SUBJECT: ISSUANCE OF AMENDMENT (TAC NO. M84247)

The Commission has issued the enclosed Amendment No. 164 to Facility Operating License No. DPR-65 for Millstone Nuclear Power Station, Unit No. 2, in response to your application dated August 12, 1992.

Amendment No. 164
License No. DPR-65

RELATED TO AMENDMENT NO. 164

FIGURE 2.2-2 Local Power Density – High Trip Setpoint Part 2 (QR_2 Versus Y_1)

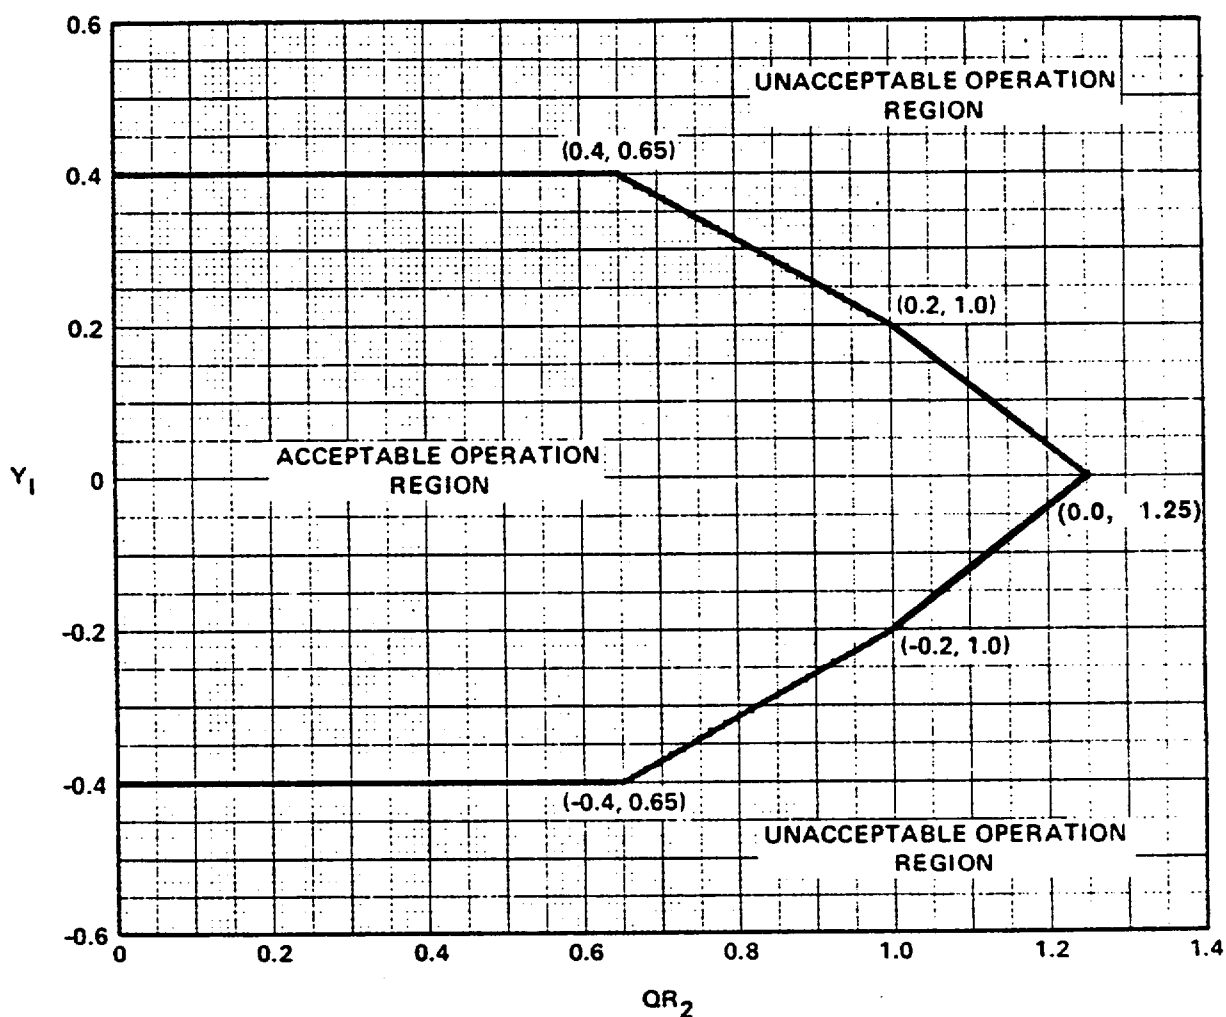
The local power density (LPD) trip setpoint peak in TS Figure 2.2-2 would be reduced from 135% to 125% at 0 axial shape index (ASI). This decrease in LPD operability margin will provide a relative increase in F_{CT} margin and allow an extension in cycle length. The licensee has confirmed that the safety analyses for Cycle 12 have shown that fuel centerline melting will not occur for any normal operating condition or anticipated operational occurrence with the higher F_{CT} for the Cycle 12 core. The proposed change is, therefore, acceptable.
